| Project | IEEE P802.15 Working Group for Wireless Personal Area Networks (WPANs) | | | | | | |
| Title | Clause 7 - FSK Draft | | | | | | |
| Re: | [802.15.4 Amendment 4g] | | | | | | |
| Abstract | [Proposed Content for Clause 7 of FSK draft.] | | | | | | |

Replace Figure 81 as indicated:

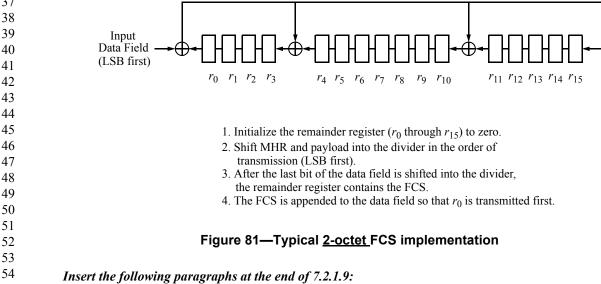
CRC-16 Generator Polynomial: $G(x) = x^{16} + x^{12} + x^5 + 1$

The 4-octet FCS is calculated using the following standard generator polynomial of degree 32:

$$G_{32}(x) = x^{32} + x^{26} + x^{23} + x^{22} + x^{16} + x^{12} + x^{11} + x^{10} + x^8 + x^7 + x^5 + x^4 + x^2 + x + 1$$
(43)
